DEVELOPMENT PROJECT APPLICATION FORM

Project Name: Village of Pemberton Daycare

- A0.0 COVER PAGE
- A0.1 CONSTRUCTION ASSEMBLIES, ROOF PLAN
- A0.2 CODE REVIEW
- A0.3 SITE PLAN
- A0.4 SERVICES PLAN
- A1.0 OVERALL FLOOR PLAN
- A1.1 AREA PLAN
- A1.2 WINDOW & DOOR LEGENDS
- A2.0 OVERALL CRAWL SPACE PLAN
- A3.0 EXTERIOR ELEVATIONS
- A4.0 BUILDING CROSS SECTIONS
- A4.1 BUILDING WALL SECTIONS
- A4.2 STAIR & RAMP DETAILS
- A8.0 OVERALL RCP

PROJECT TITLE: VILLAGE OF PEMBERTON 7396B COTTONWOOD STREET DAYCARE		P22973	As indicated
DRAWING TITLE: CONSTRUCTION ASSEMBLIES, ROOF PLAN		DRAWN BY: RMM	DATE: 26 MAY 2023
		A0.1

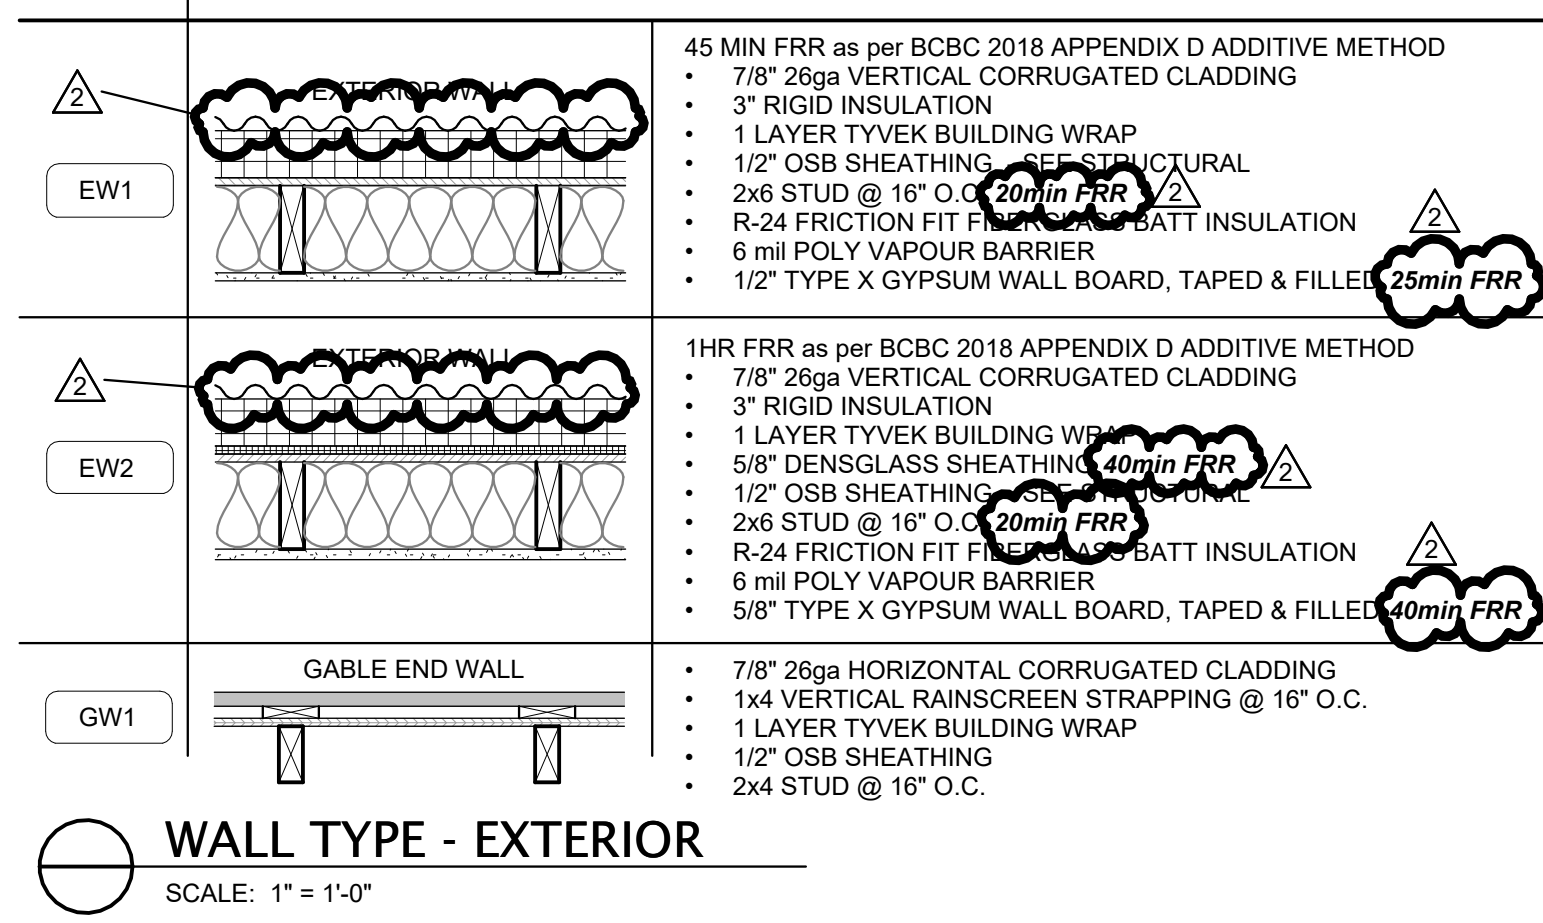
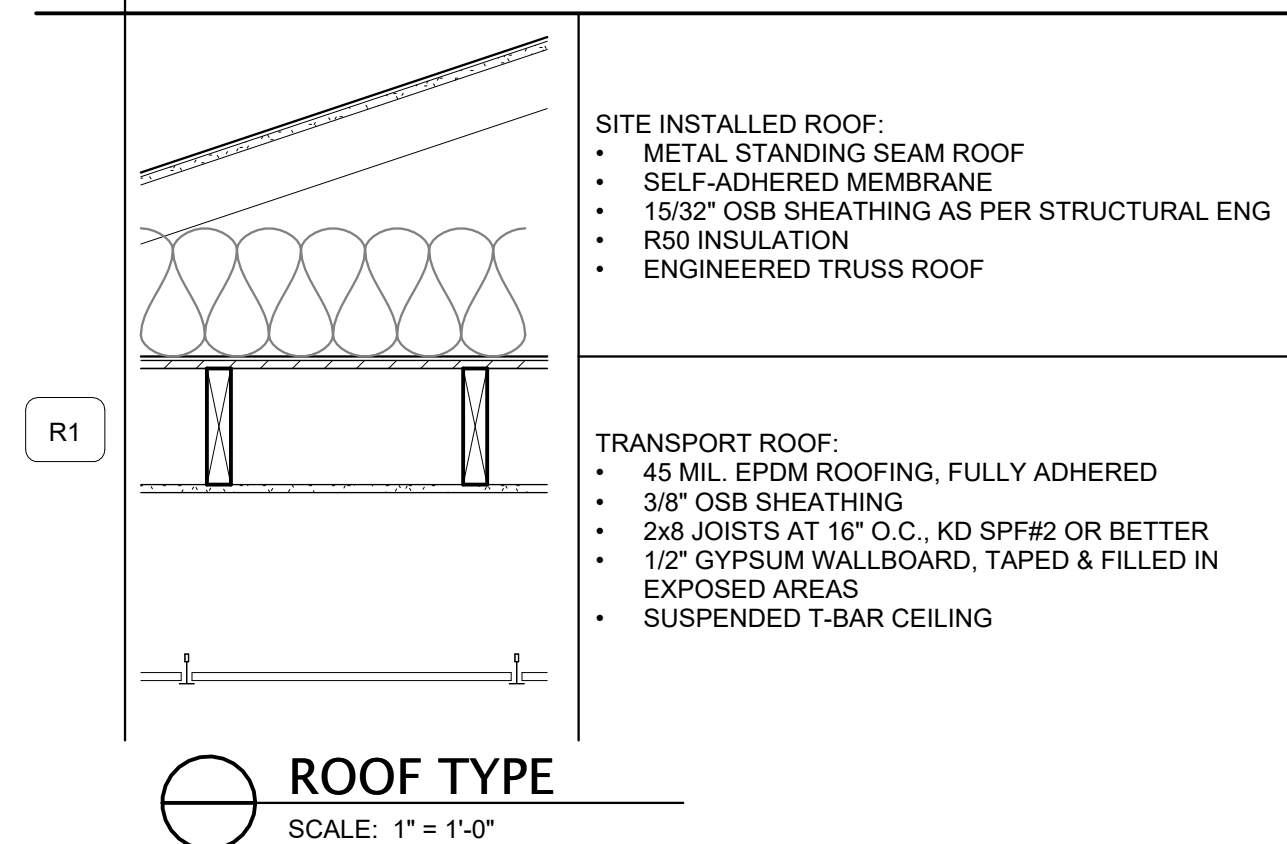
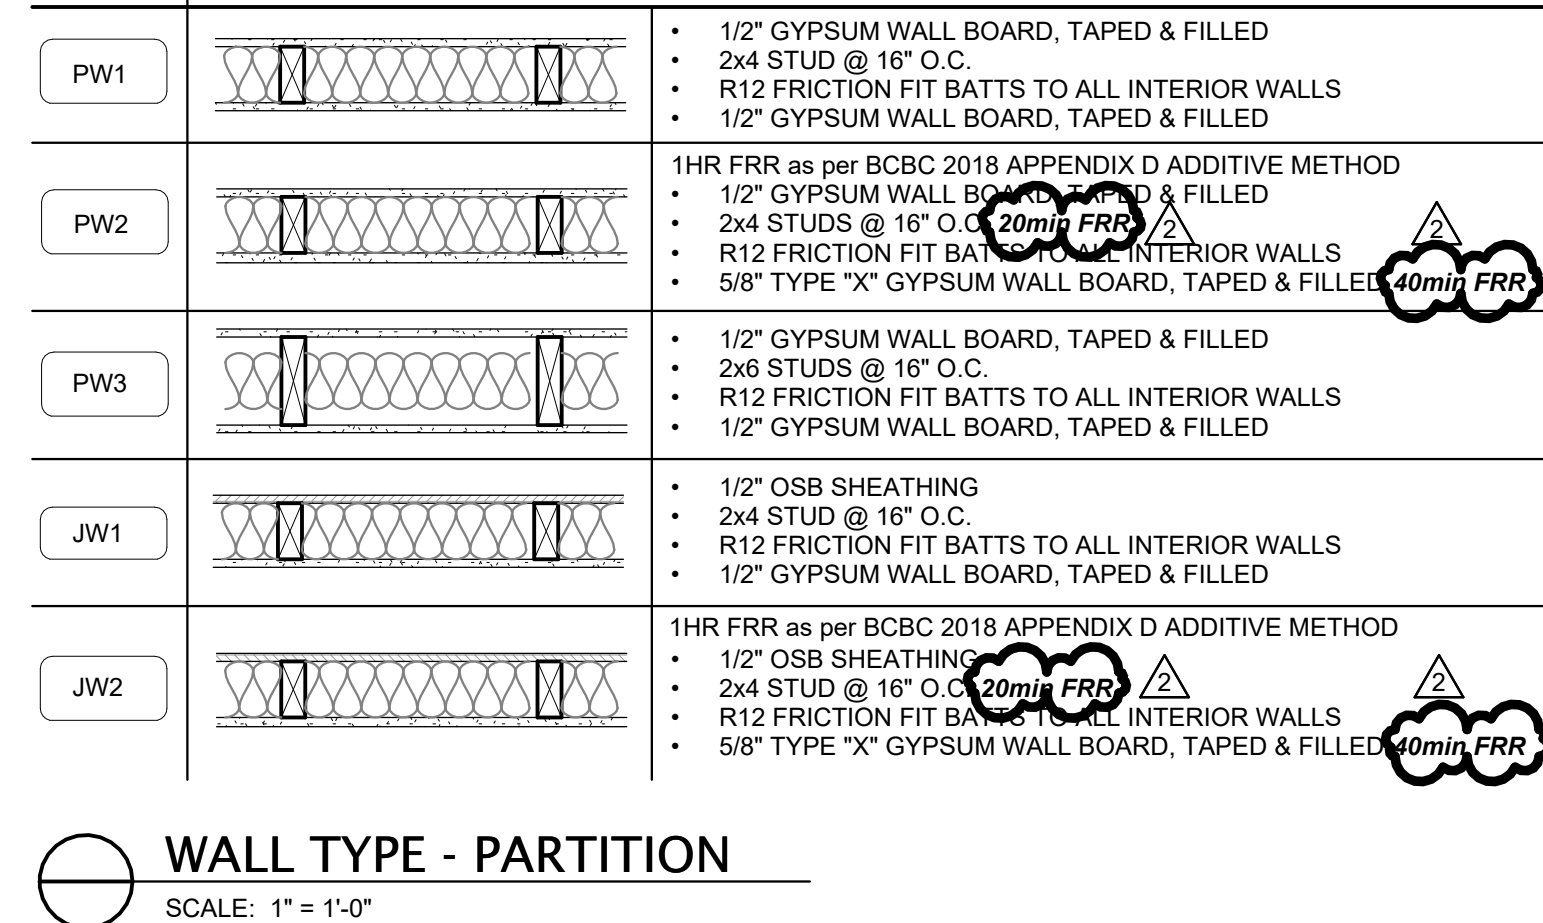
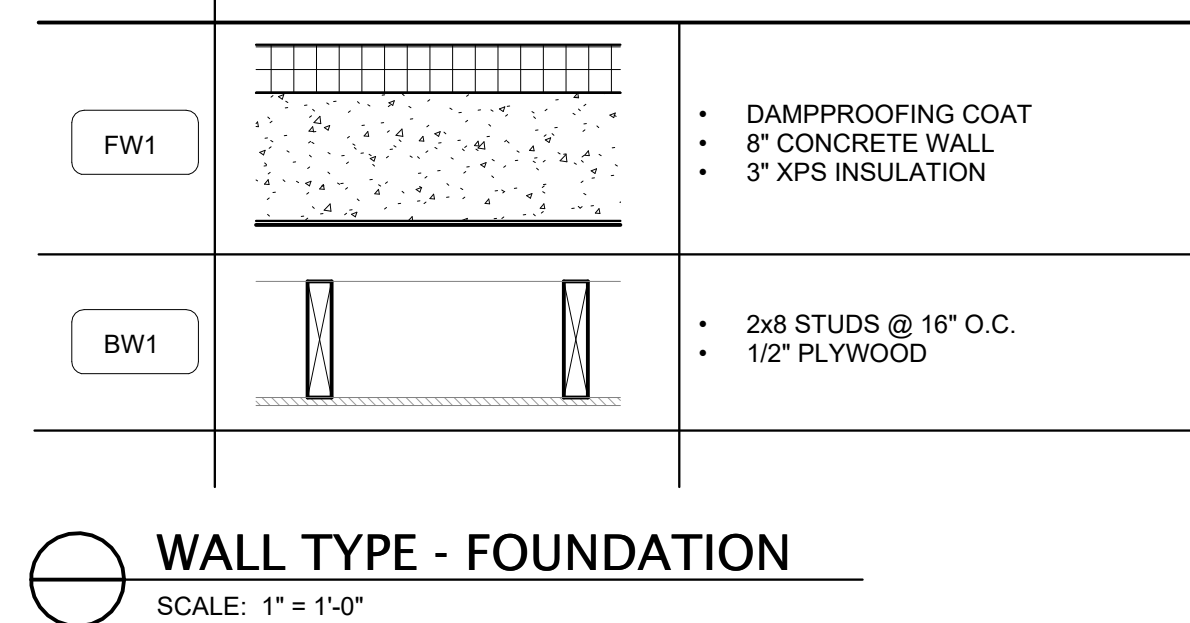
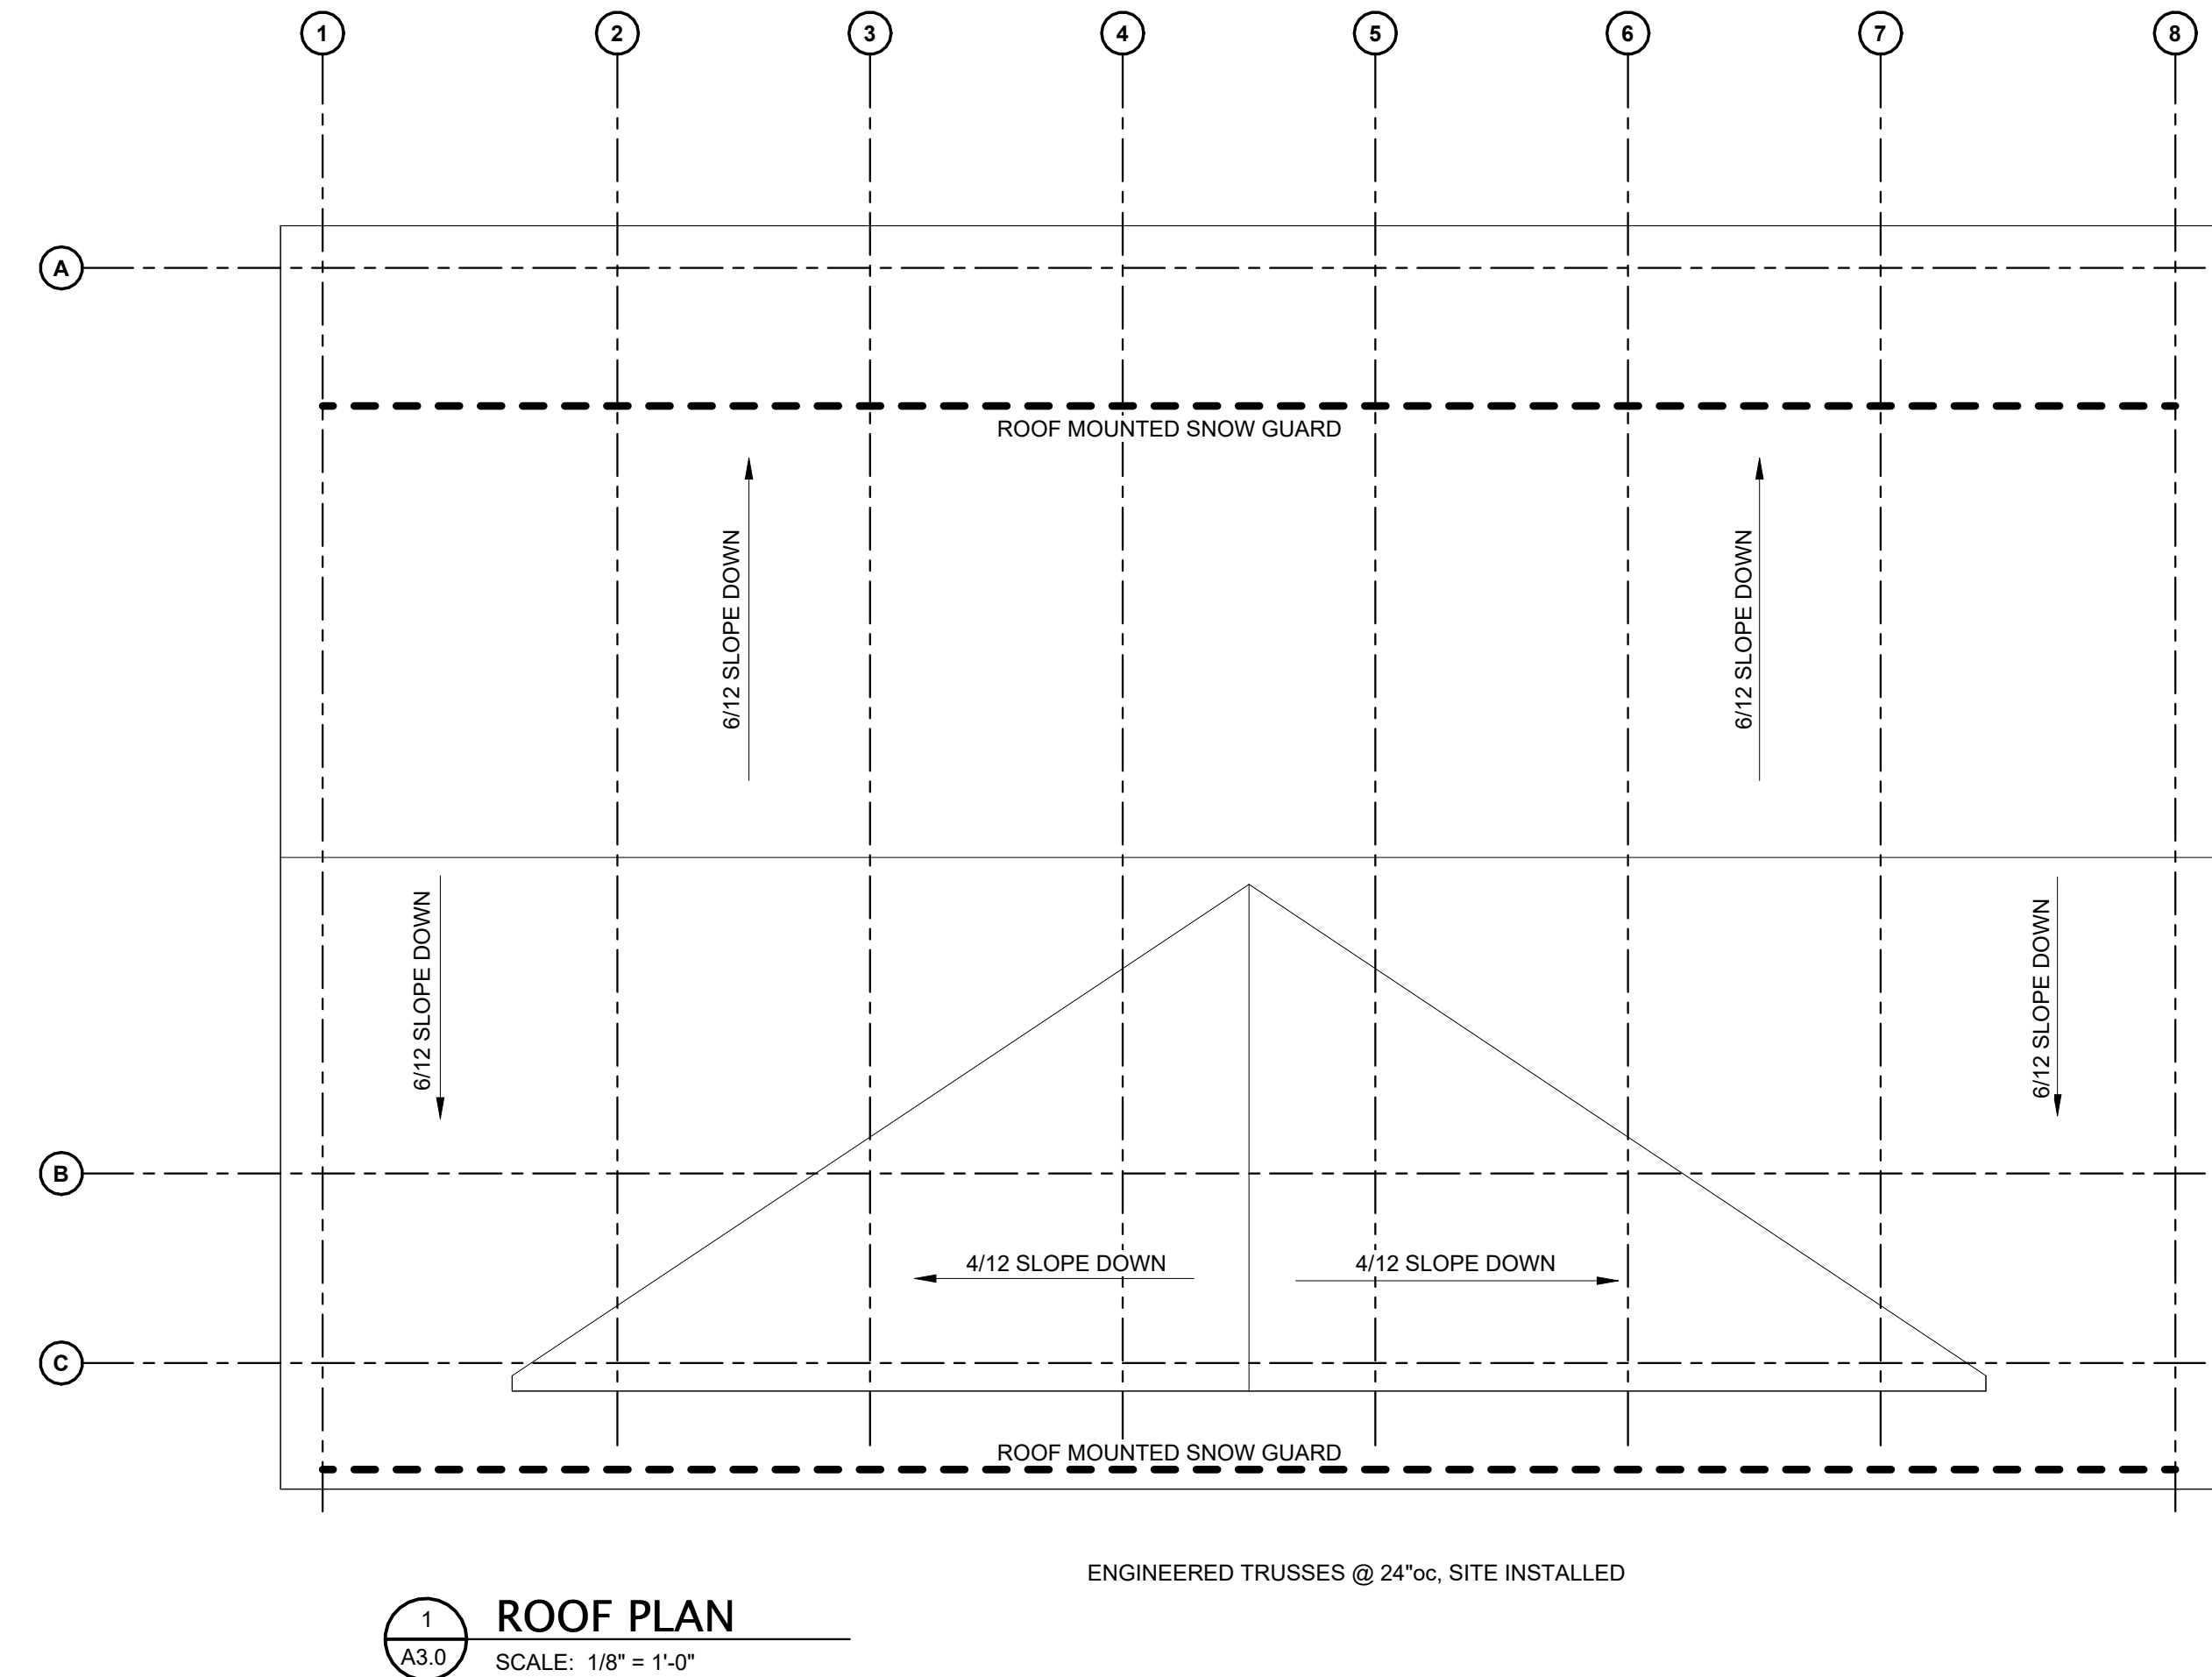
- WALL SYSTEMS SHALL COMPLY WITH RAIN SCREEN REQUIREMENTS, SECTION 5.6, DIVISION B, BCBC 2018.
- FIRE BLOCKING IN CONCEALED SPACES SHALL BE IN CONFORMANCE WITH 3.1.11., PART 3, DIVISION B, BCBC 2018.
